**TECHNICAL EVALUATION REPORT  
DRESDEN STATION UNITS 2 AND 3  
STATION BLACKOUT EVALUATION**

*Science Applications International Corporation*  
*An Employee-Owned Company*

Figure 1: Dresden Electrical One Line Diagram With AAC

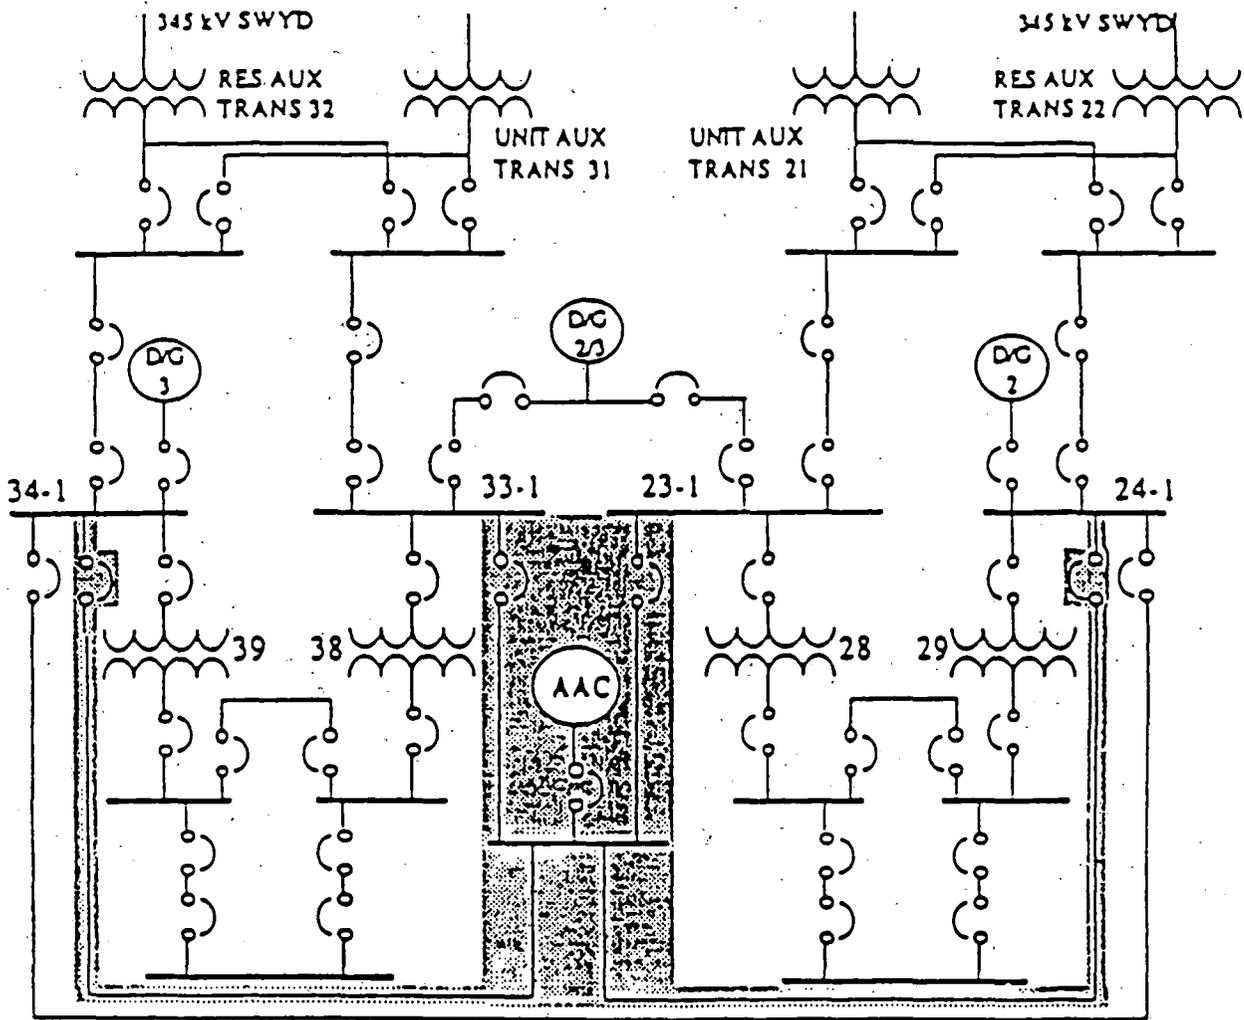
Although the licensee is committed to install an AAC which conforms to the guidance provided in Appendix B to NUMARC 87-00, it did not provide sufficient information to review the proposed modification. The only information supplied is that the AAC will be a non-class 1E diesel generator with a 2000 hour rating of 5700 kW and that it would be

available within one hour. With a capacity of 5700 kW, the proposed AAC power source would produce twice the power of an EDG, hence it would be capable of powering one safety train of each unit simultaneously. This capacity is considered adequate.

The proposed circuits for connecting the AAC power source to the safe shutdown buses may be credited as the cross-tie between safety buses 23-1 and 33-1. However, all of the connections from safety buses 23-1, 24-1, 33-1, and 34-1 to the AAC power source output circuit breaker would have to be safety grade since all these circuits are directly connected to the AAC power source output breaker.

The detailed design of the AAC power source needs to be reviewed to verify that the requirements of NUMARC 87-00 Appendix B are met.
